SUNDRY NOTICES AND REPORTS ON WELLS

8. Well Name and No.
Brennan Fed. Com #1

9. API Well No.
30-041-20911

**Brennan Fed Com 1
Manzano, LLC
January 30, 2019
Conditions of Approval**

Manzano, LLC
 Brennan Fed. Com #1
 API 30-041-20911
 WBD After P&A

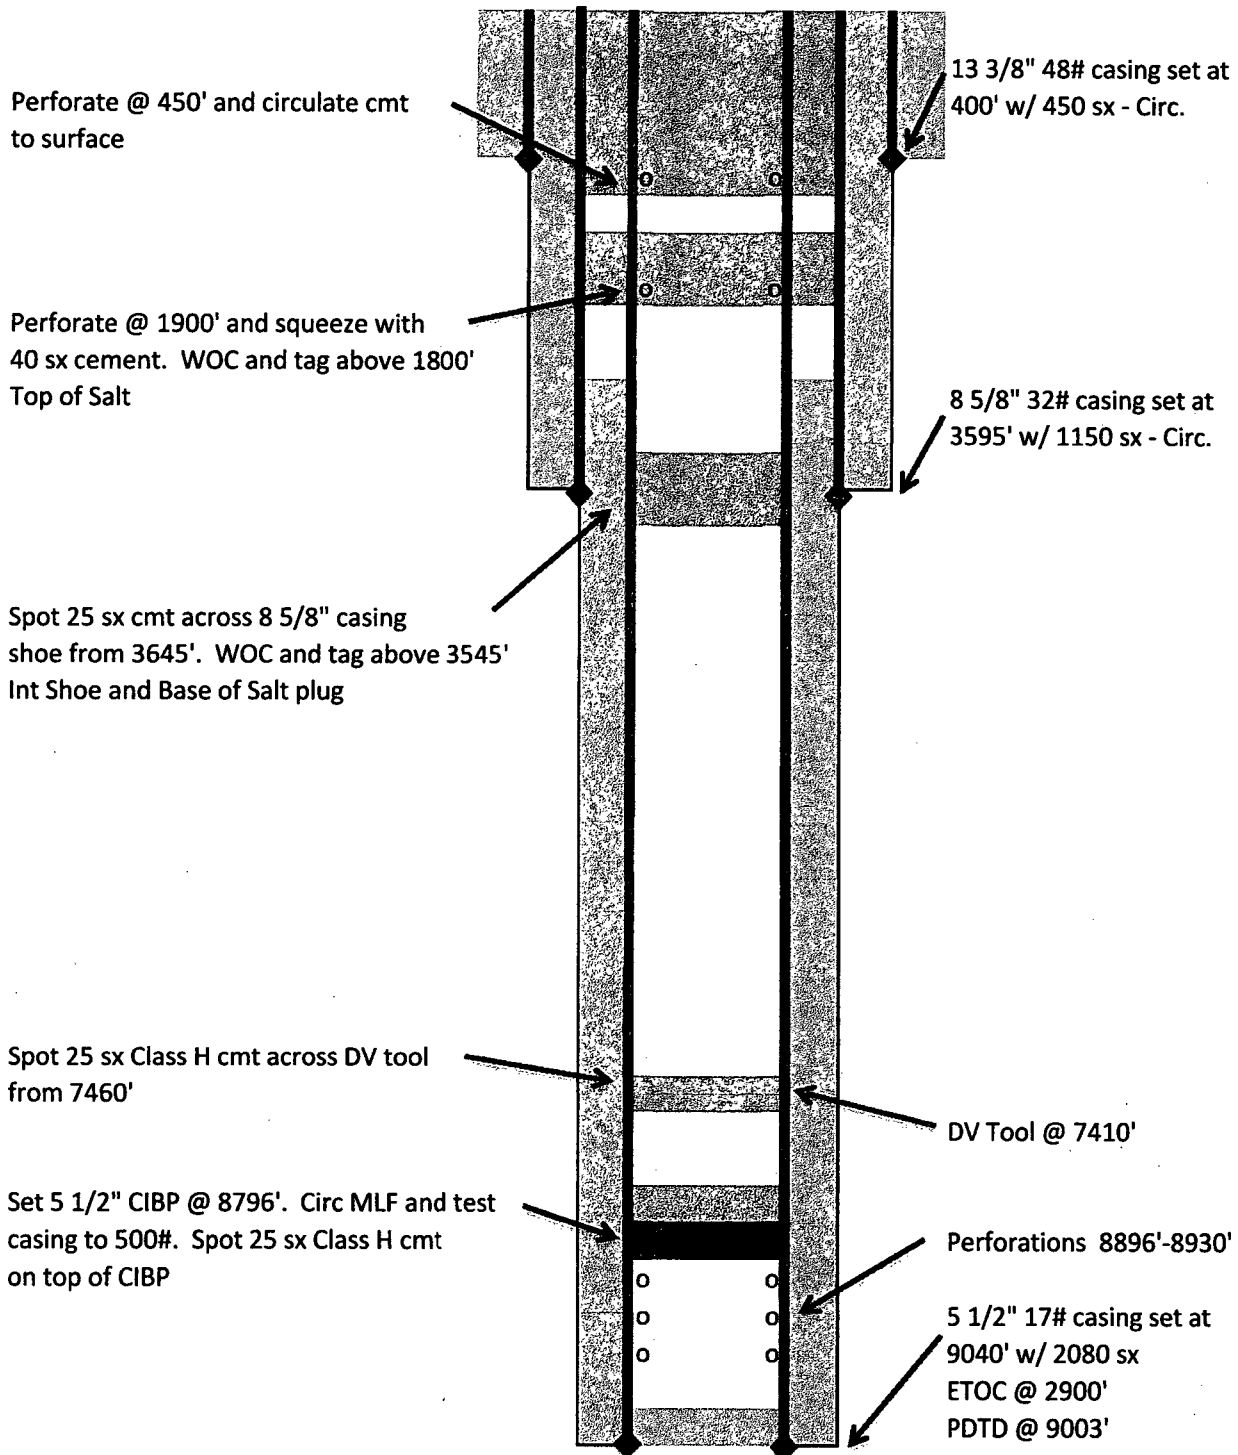
1. Operator shall place CIBP at 8,796' (50'-100' above top most perf) and place 25 sx of Class H cement on top as proposed. WOC and TAG.
2. Operator shall place a balanced Class H cement plug from 7,790'-7,610' to seal the top of the Wolfcamp Formation.
3. Operator shall place 25sx Class H cement at 7,460' as proposed to seal the DV tool. WOC and TAG. Tag must be a minimum of 7,360'.

Note: Operator may combine plugs 2 and 3.

4. Operator shall place a balanced Class C cement plug from 6,940'-6,770' to seal the top of the Abo Formation.
5. Operator shall place a balanced Class C cement plug from 5,500'-5,345' for the purpose of a spacer plug as no more than 3,000' is allowed between plugs.
6. Operator shall place 25sx Class C cement at 3,645' as proposed to seal the 8-5/8" shoe. WOC and TAG. Tag must be a minimum of 3,545'.
7. Operator shall perf and squeeze at 2,215'. Operator shall place a balanced Class C cement plug from 2,215'-2,095' to seal the Yates formation. WOC and TAG.
8. Operator shall perf and squeeze at 1,950'. Operator shall place 40sx Class C cement as proposed to seal the Salt formation. WOC and TAG a minimum of 1800'.

Note: Operator may combine plugs 7 and 8.

9. Operator shall perf and squeeze at 450. Operator shall place a balanced Class C cement plug from 450'- surface to isolate the 13-3/8" shoe.
10. See Attached for general plugging stipulations.
